World Forum for Harmonization of Vehicle Regulations

Proposal for the 03 series of amendments to UN Regulation No. 100 (Electric power trained vehicles)

Submitted by the Working Party on Passive Safety *

Figure 1
Schematic to Measure Wrap-Around Distance

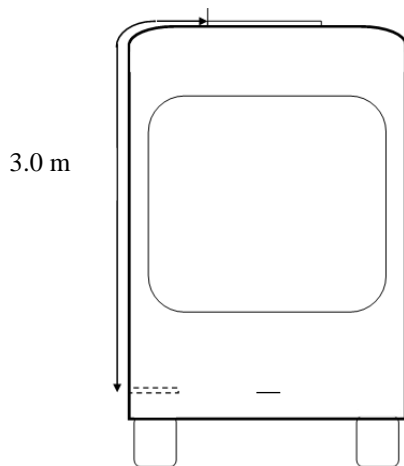
For vehicles of categories N₂, N₃, M₂ and M₃, conductive connection devices not energized except during charging of the REESS are exempted from this requirement if located on the roof of the vehicle out of reach for a person standing outside of the vehicle and, for vehicles of category M₂ and M₃, the minimum wrap around distance from the instep of the vehicle to the roof mounted charging devices is 3 m. In case of multiple steps due to an elevated floor inside the vehicle, the wrap around distance is measured from the bottom most step at entry, as illustrated in Figure 1.

"Figure 1
Jointed Test Finger

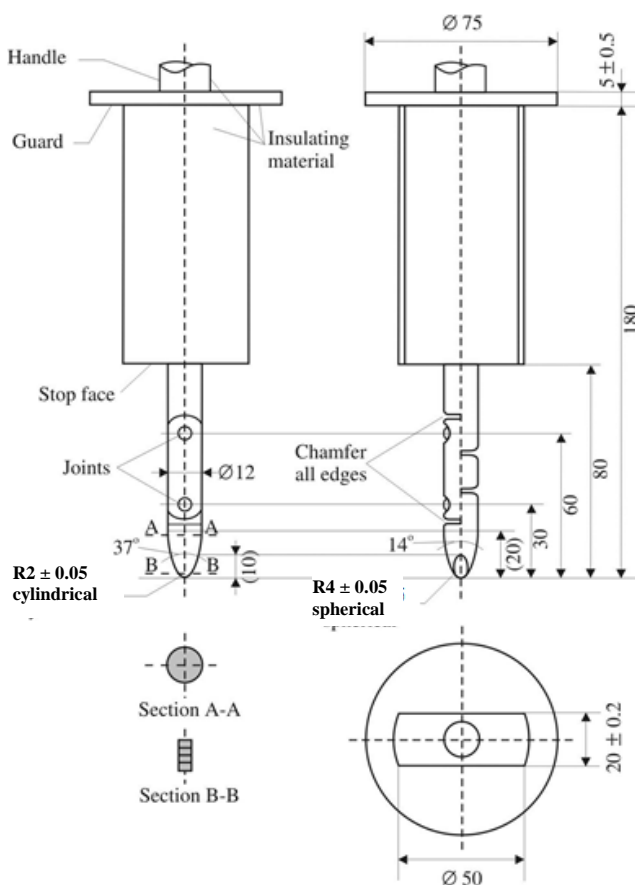
Figure 1, shall be deleted

Insert a new Figure 1, to read:

Material: metal, except where otherwise specified

Both joints shall permit movement in the same plane and the same direction through an angle of 90° with a 0 to $+10^\circ$ tolerance. "
